Our Ref: BNE250111

Property Location:	1035-1037 Wynnum Road & 4 Dorothea Street, Cannon Hill QLD 4170
Property Description:	Lots 1-2 on RP84110 & Lot 23 on RP70990
Development:	Other Change to a Development Approval under section 78 of the Planning Act 2016 – Development Permit for Material Change of Use for Multiple Dwelling (Council Reference: A005637070)
Applicant:	Genius Loci Property Pty Ltd
Council Reference:	A007057417

We refer to Council's Information Request dated 4 August 2026 and, on behalf of our client, forward the following as a full response to all requested items in accordance with section 13.2(a) of the DA Rules.

Figure 2 Proposed Southern Boundary Landscaped Interface

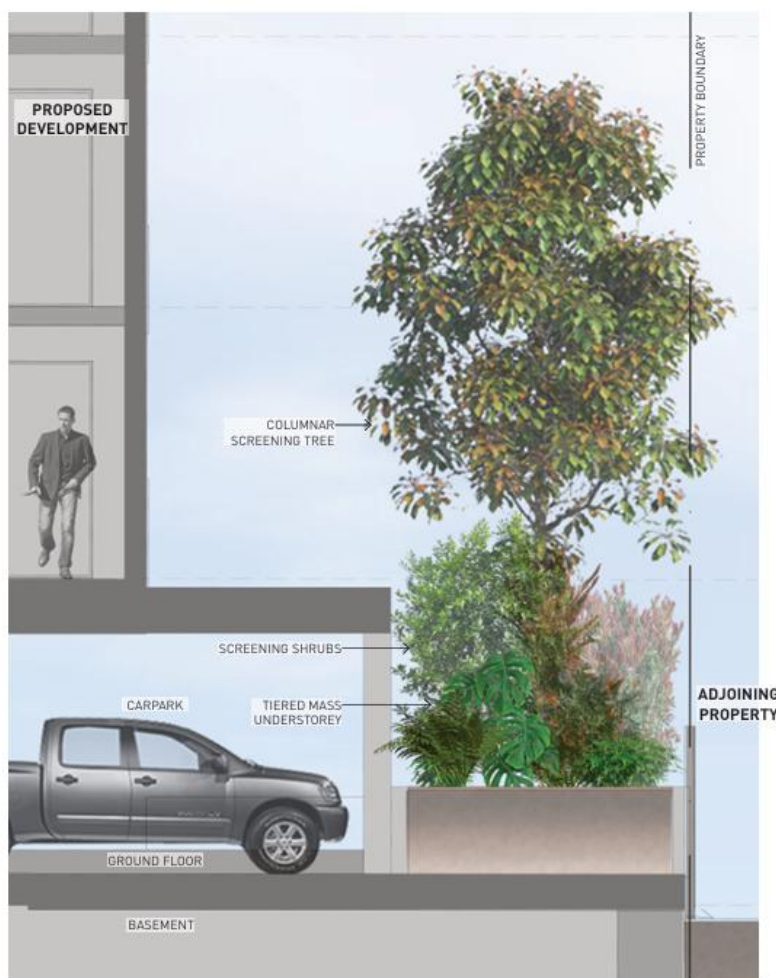
3) The landscaping buffers along the southern and western property boundaries have been reduced to less than 1.5m contrary to AO28.2 of the Multiple dwelling code and AO57.1 and AO62.1 of the Centre or mixed use code. The open car parking spaces at ground level also do not achieve a setback to the same boundaries above in accordance with AO41.1 of the Centre or mixed use code and AO34.1 and AO35.1 of the Multiple dwelling code. The resulting car park and landscaping areas remove landscaping that will reduce the appearance of building bulk and scale and contribute to privacy and amenity between the adjoining properties. Landscaping is also necessary in minimising the impacts of the building height along the southern property boundary.

a) Submit amended drawings and an amended landscape concept plan that provides a 1.5m wide landscaping strip between car parking and manoeuvring areas and the southern and western property boundaries to meet PO1 and PO5 of the River gateway neighbourhood plan code, PO28/AO28.2 of the Multiple dwelling code and PO55/AO55, AO57.1 and PO62 of the Centre or mixed use code and PO3, PO4 and PO7 of the Landscape work code. The soil depths are to be in accordance with the Landscape design planning scheme policy to accommodate screening shrubs and tree species to provide amenity and privacy. The landscape concept plan is to show buffer planting species and stock sizes that allow for safe, efficient and effective landscape maintenance can be undertaken.

b) Submit landscape cross sections through the side boundaries to illustrate the landscape buffer outcomes to be delivered. Note: It is recommended that the second basement level is reintroduced to address Item 2 and 3.

The architectural design has been updated to increase the southern side setback to the ground level car park to introduce a 2.45m – 3.75m wide landscape buffer. This has been achieved through removing the two car parking spaces from the south-eastern corner of the ground floor. As illustrated on the updated Landscape Concept Plan (**Appendix B**), the area will comprise columnar screening trees, screening shrubs and understorey planting.

The extent of buffer planting to the southern boundary exceeds the current development approval which comprises a width of 1.65m, suitable for screening shrubs only. The introduction of canopy trees to the southern boundary, in addition to the screening shrubs and understorey planting, will provide amenity, privacy and support building height transition to the adjoining property in accordance with PO1 and PO5 of the River gateway neighbourhood plan code; PO28 of the Multiple Dwelling Code; PO55, PO77 and PO62 of the Centre or mixed use code and PO3, PO4 and PO7 of the Landscape work code.

The updated Landscape Concept Plan includes a cross section through the southern boundary interface as illustrated under **Figure 2** below.

Figure 3 Southern Elevation Comparison

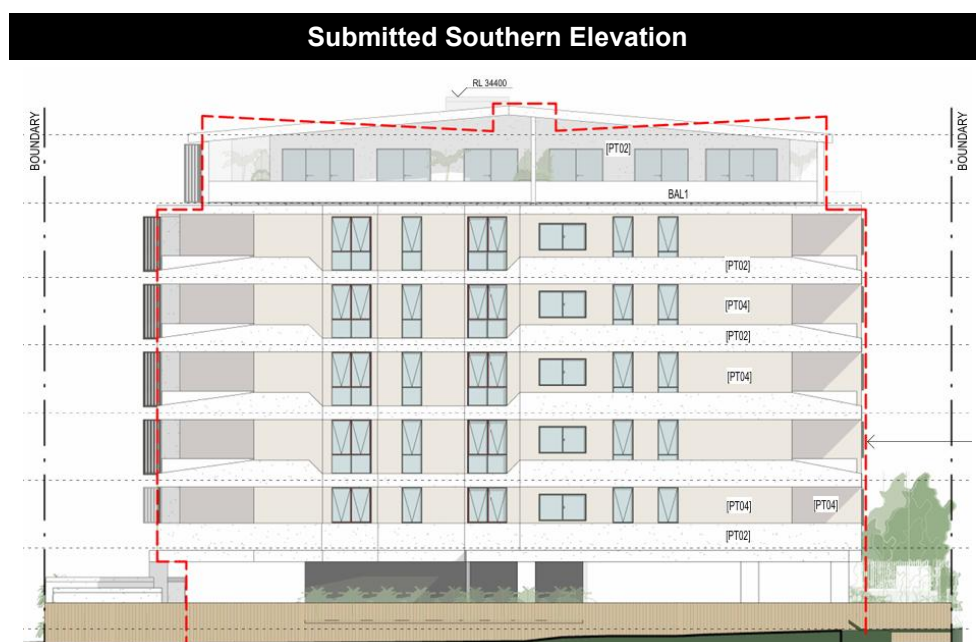
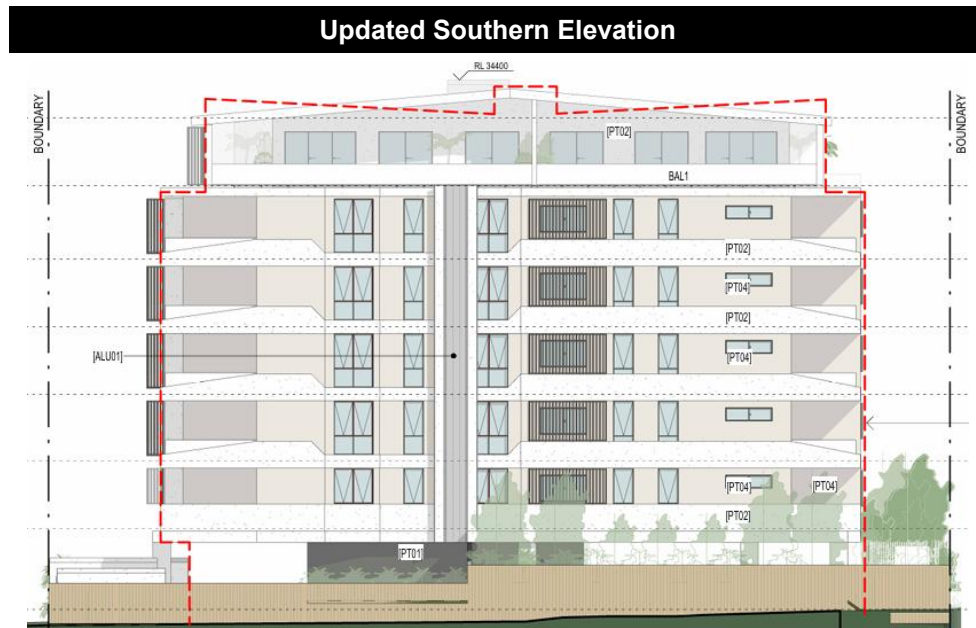
5) The level of articulation though slightly simplified, continues to be of similar proportions to that originally approved. However, a comparable material and finish to the larger portions of rendered wall incorporating vertical grooves to break up the bulk and scale of the proposed development is recommended.

a) Submit amended drawings that provide additional design solutions to break up the bulk and scale to meet PO9 of the Multiple dwelling code.

The updated Architectural Plans (**Appendix A**) include revisions to the southern elevation to manage building bulk and scale as requested. The updated elevation treatments include the introduction of:

- Aluminium vertical screen feature running from Level 1 to Level 5;
- Additional high-level windows in the living area of each south-eastern unit;
- Fixed vertical batten screening to bedroom 2 also of each south-eastern unit.

The updates to the southern façade provide additional articulation and variation, breaking up the extent of rendered wall, in accordance with PO9 of the Multiple Dwelling Code.
